# Access Compliance Report

## Public Rights-of-Way

### (Curb Ramps)

Intersection ID: 32286	Main Street: LANDING_PLACE_LN	Cross Street: SULLIVAN_RIDGE_DR	Location: SE
ADA ID: 1358FEEC1EA6	Ramp Type: PerpDiag	Initial Pass/Fail: Fail	Overall Compliance: No
Severity Score: 21.25			
Codes/Mitigation Info/Possible Solution		Field Measurements/Component Compliance

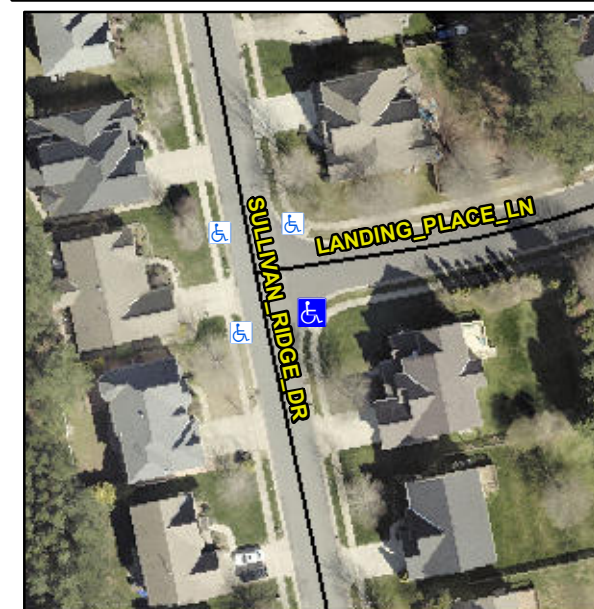
**Not Found, R304.5.1, R304.2.2**

Compliance	Description	Data	Compliance	Description	Data
N/A	Ramp Length (in)	51.0	No	Ramp Slope (%)	10.5
No	Ramp Width (in)	46.0	Yes	Ramp XSlope (%)	1.4
N/A	Flare Type LT	N/A	N/A	Flare Type RT	N/A
N/A	Flare Slope LT (%)	N/A	N/A	Flare Slope RT (%)	N/A
N/A	Flare Traversable LT?	N/A	N/A	Flare Traversable RT?	N/A
N/A	Landing Length (in)	N/A	N/A	DWS Provided?	N/A
N/A	Landing Width (in)	N/A	N/A	DWS Contrast?	N/A
N/A	Landing Slope (%)	N/A	N/A	DWS Length (in)	N/A
N/A	Landing X Slope (%)	N/A	N/A	DWS Full Width?	N/A
N/A	Landing Curb? (Y/N)	N/A	N/A	DWS Offset (in)	N/A
N/A	Shared Landing?	N/A			
N/A	Gutter Ponding?	N/A	N/A	Gutter Slope (%)	N/A
N/A	Gutter Lip Ht (in)	N/A	N/A	Gutter X Slope (%)	N/A
N/A	Painted X Walk1?	No	N/A	Painted X Walk2?	No
	X Walk 1 Direction	To N		X Walk 2 Direction	To W
N/A	X Walk 1 Width (in)	N/A	N/A	X Walk 2 Width (in)	N/A
	X Walk 1 Slope (%)	1.7		X Walk 2 Slope (%)	2.1
	X Walk 1 X Slope (%)	3.3		X Walk 2 X Slope (%)	3.3

**Remove & Replace Curb Ramp With Two New Directional Ramps or Equivalent.**
